**Record of Decision for Interim Remedial Action
at Solid Waste Management Units 2 and 3
of Waste Area Group 22
at the Paducah Gaseous Diffusion Plant
Paducah, Kentucky**

RECORD OF DECISION (ROD) FOR INTERIM REMEDIAL ACTION (IRA) AT SOLID WASTE MANAGEMENT UNITS (SWMUs) 2 AND 3 OF WASTE AREA GROUPING (WAG) 22 AT THE PADUCAH GASEOUS DIFFUSION PLANT (PGDP)

Subject: Contract No. DE-AC05-93OR22028, Task Order No. 36—Transmittal of the Record of Decision for Interim Remedial Action at Solid Waste Management Units 2 and 3 of Waste Area Group 22 at the Paducah Gaseous Diffusion Plant, Paducah, Kentucky DOE/OR/06-1351&D1

**Record of Decision for Interim Remedial Action at Solid Waste Management Units 2 and 3
of Waste Area Group 22 at the Paducah Gaseous Diffusion Plant, Paducah, Kentucky
DOE/OR/06-1351&D0 (issued March 1995)**

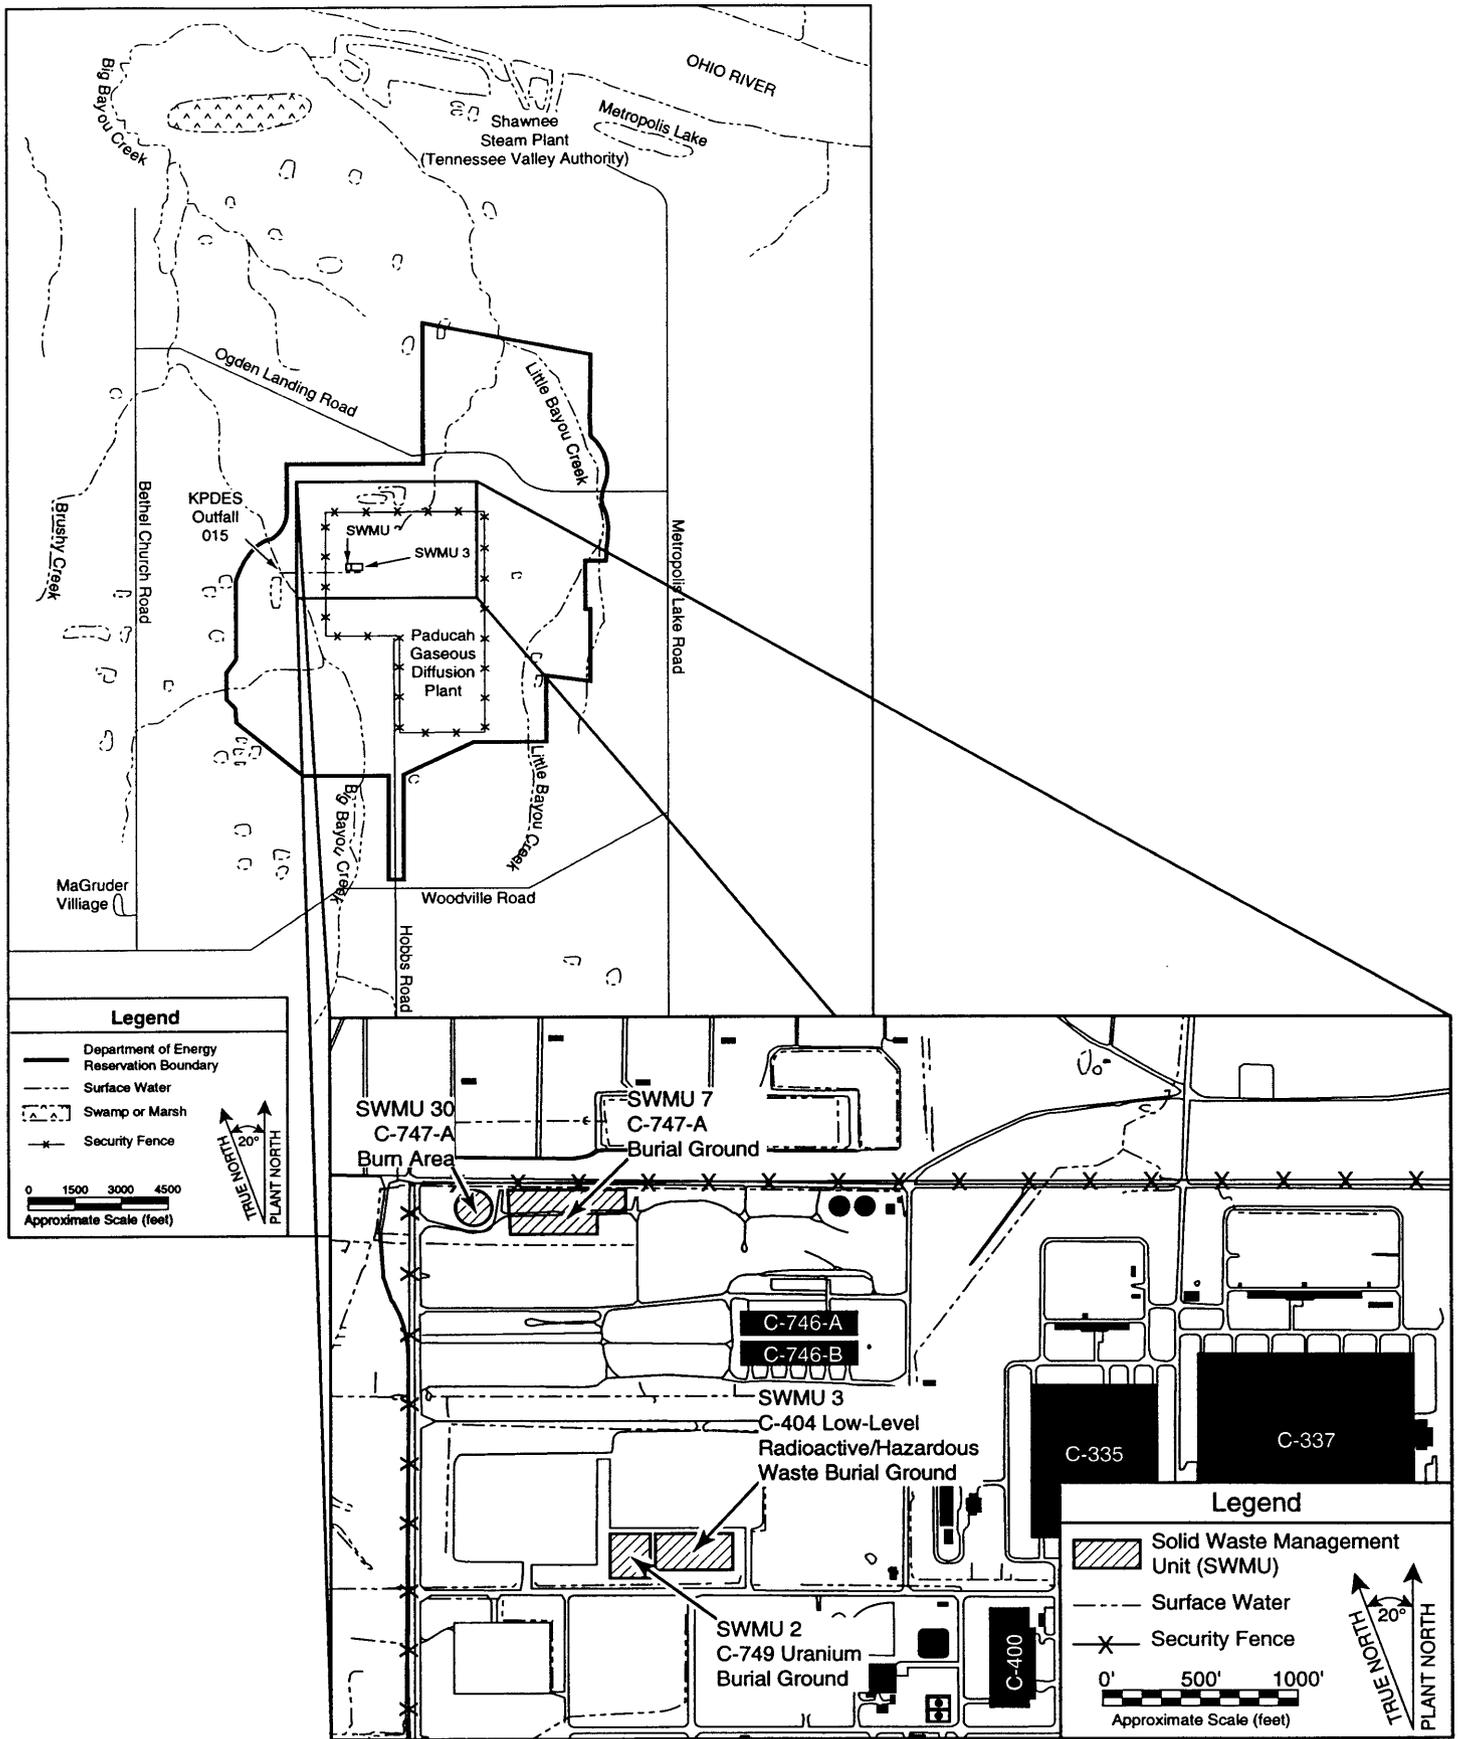
Comment Number	Page; Section; Para.	Reviewer and Comment	Response
159.	Pages 10 through 13 and Figure 2-1; Section 2.5	LMES/J. W. Morgan: "The <u>intent</u> of the discussion of COCs and the corresponding table is confusing. Does the table reflect all contaminants of concern, those that are naturally occurring, or both? Is this section committing us to sampling for all these COCs during the Sampling and Analysis activities. Additional clarification may be needed."	The table was intended to identify <u>all</u> COCs as evaluated in the FS. The table has been deleted in response to Comment #1. No commitments has been made in the ROD concerning the analytes for the proposed sampling and analysis activities.

Figure 2-4. Sampling Locations at Solid Waste Management Unit 2

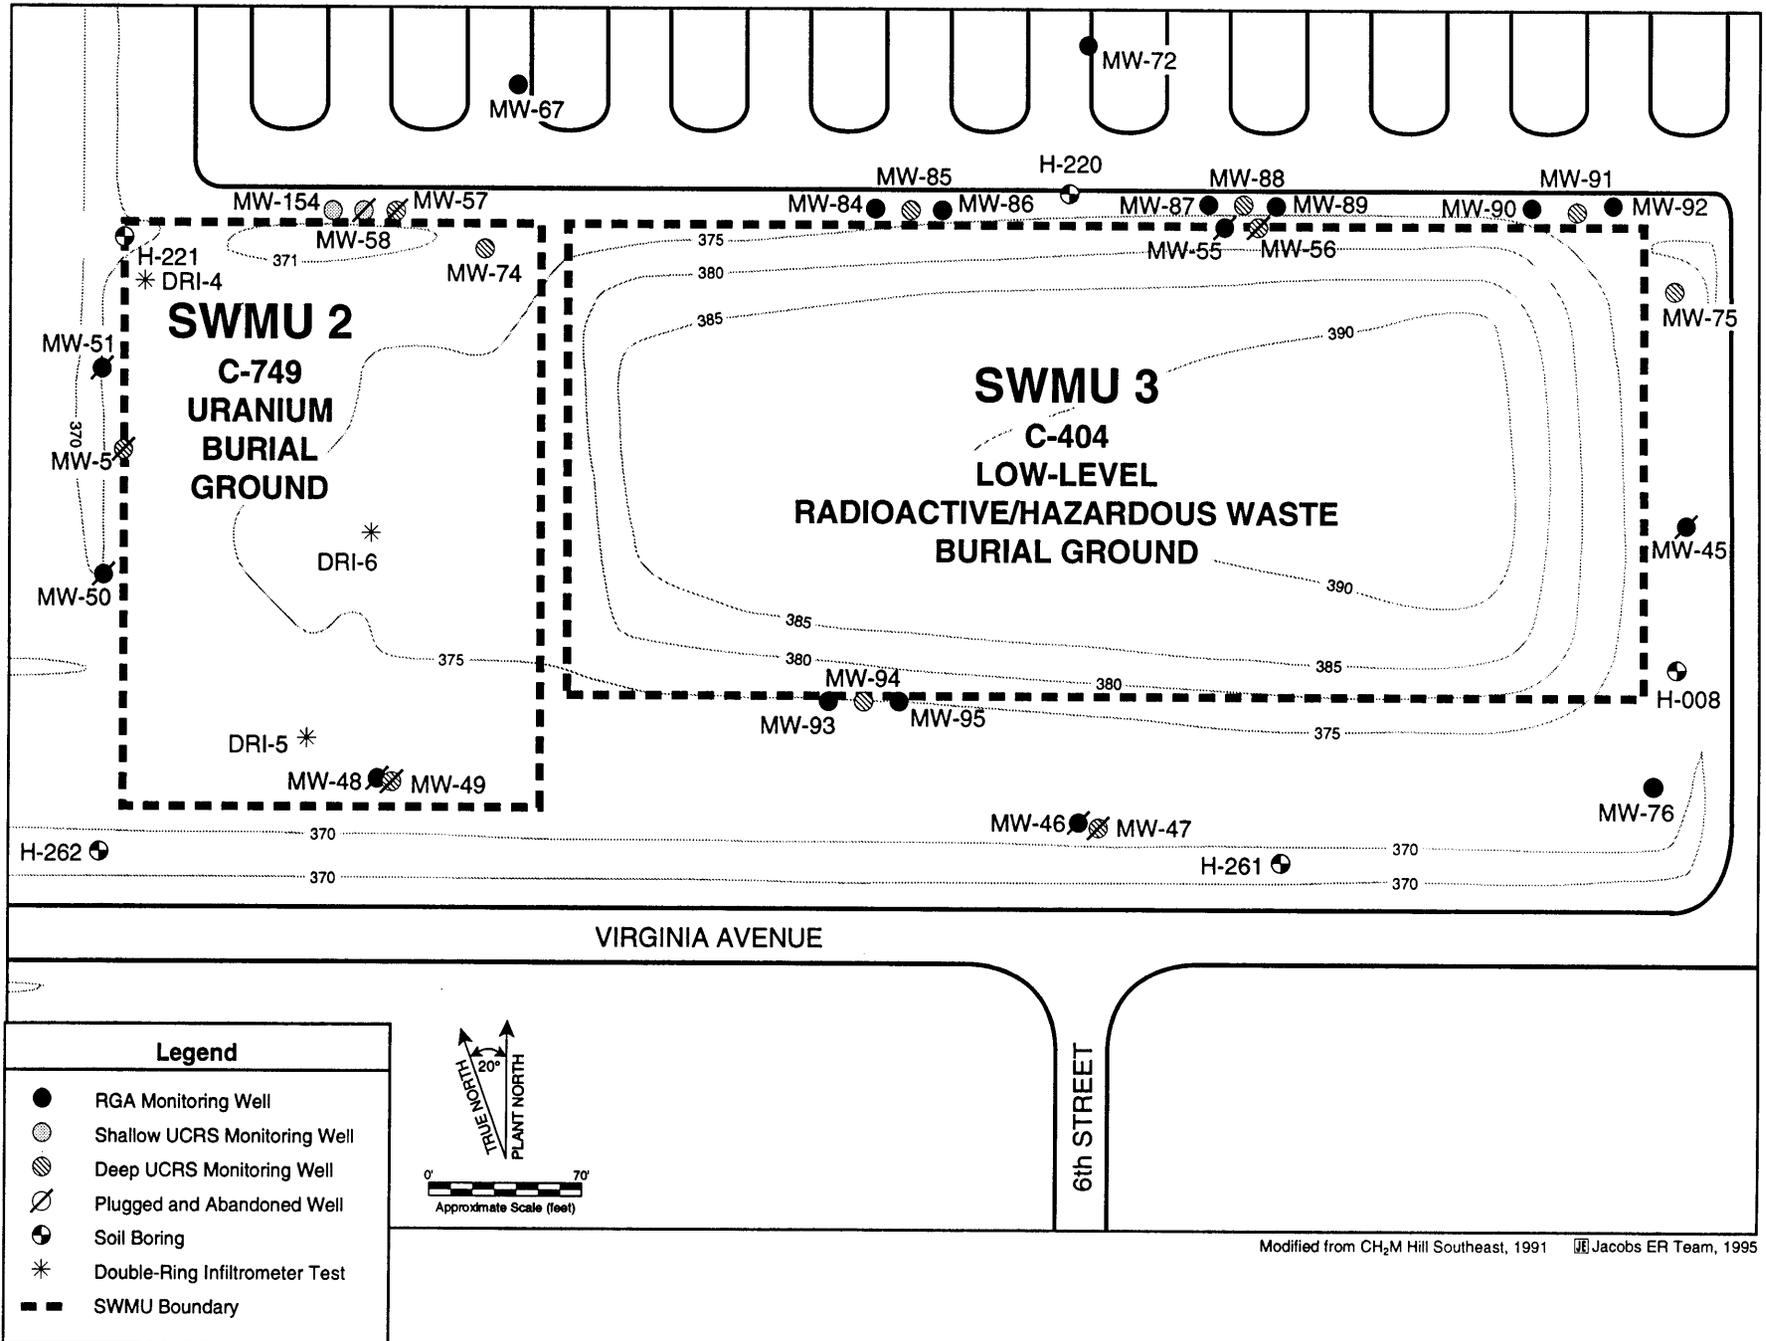
Comment Number	Page; Section; Para.	Reviewer and Comment	Response
122.	Figure 2-4; Section 2.5	LMES/T. E. Fitzgerald: "Could another line be drawn so as to separate the two SWMUs from each other."	Agree. Figure has been modified as suggested.
